**Modified Proposed Plan
for Soil and Dry Sediment at the
RVAAP-01 Ramsdell Quarry Landfill**

**Ravenna Army Ammunition Plant
Ravenna, Ohio**

**FINAL MODIFIED PROPOSED PLAN FOR SOIL AND DRY SEDIMENT AT THE RVAAP-01 RAMSDELL QUARRY LANDFILL
RAVENNA ARMY AMMUNITION PLANT, RAVENNA OHIO
COMMENT RESPONSE TABLE ~ MAY 16, 2012**

Figure 1. General Location and Orientation of RVAAP/Camp Ravenna

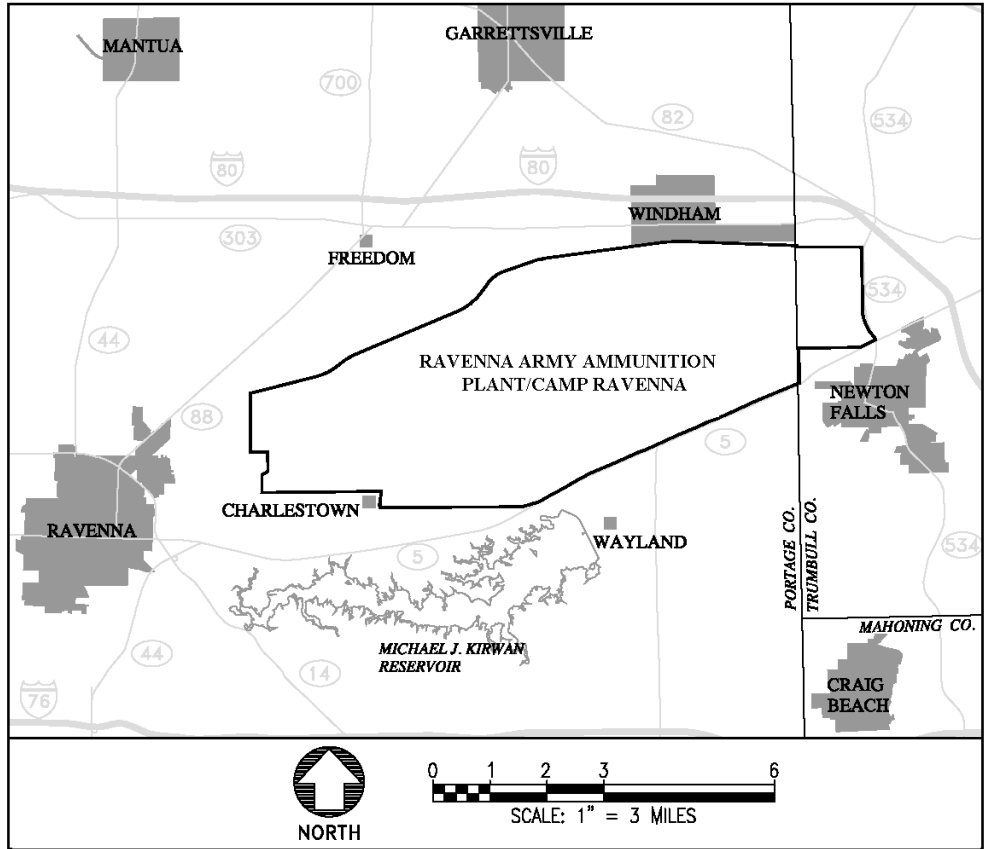
A-16.	Page 14 Figure 1		Top upper image should delineate the approximate geographical location of RQL within the RVAAP polygon	Clarification. Figure 2 delineates the geographical location of RQL within RVAAP. Figure 1 illustrates the location of RVAAP within Ohio and has been standardized in prior RVAAP reports. No change is recommended.
A-17.	Page 15 Figure 2	The title for this figure is totally out place with the drawing.	Being more relative to referencing this drawing to all current CERCLA and/or- Munitions sites associated to IRP, MMRP, CC/CR within the Ravenna Army Ammunition Plant. I’m not sure we should be associating this drawing with Camp Ravenna.	Clarification. The figure presents the layout of both RVAAP and Camp Ravenna and was previously provided by USACE to standardize all RVAAP reports. No change is recommended.

Figure 3. RQL Site Features and Proposed Fencing Extent

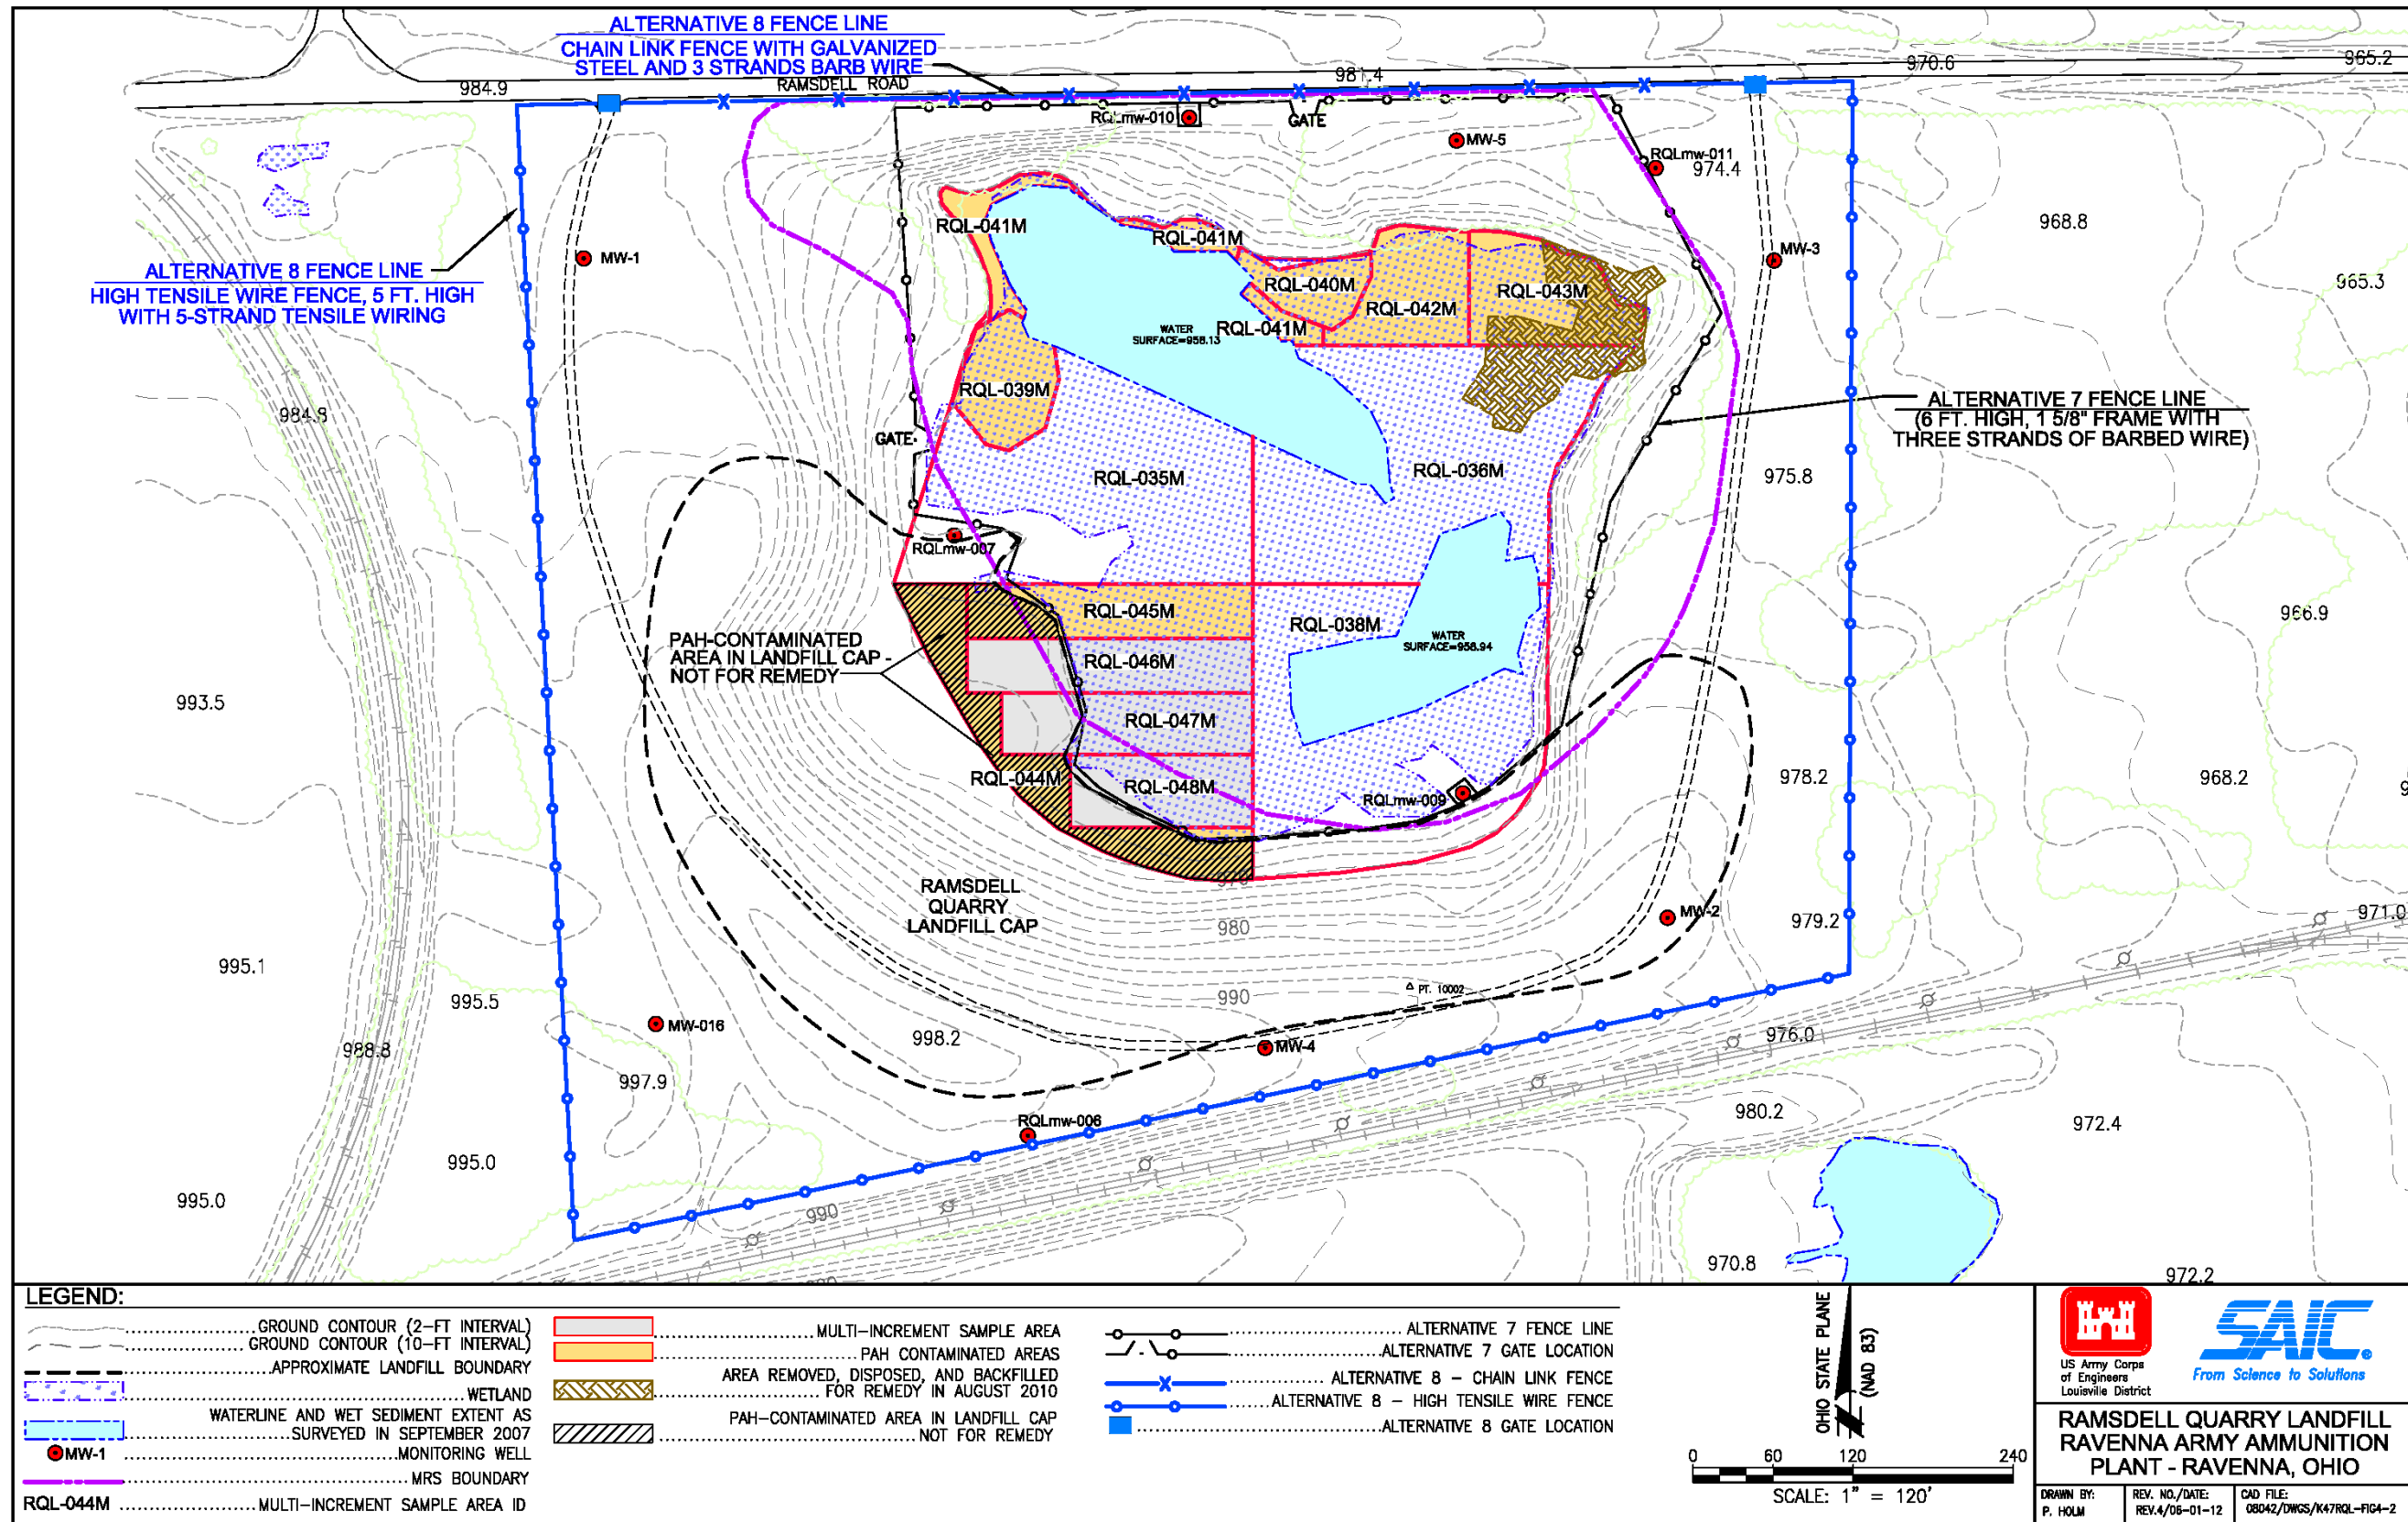
Comment Number	Page or Sheet	Comment	Recommendation	Response
				subsequently provide comments on a Final version. (e.g., if comment back-check indicates not all changes were made as agreed in the comment response process). Additional changes if required, or new comments to a Final version, have historically been addressed through issuance of a Revised Final document. No text changes recommended.
A-2.	Page i Left column of text	Section "10.0" indent one space in the line to left to align decimal with the "9.0" above it.		Clarification. The Section numbers are left justified to the established page margins consistent with prior RVAAP document formats. Indenting the space of Section 10.0 will put that line beyond the established margin. No text change recommended.
A-3.	Page i Right column of text	"Figure 3" Title is dissimilar to what exists on Page 16	Please correct the title	Agree. Figure 3 has been re-titled per the title on Page 16.
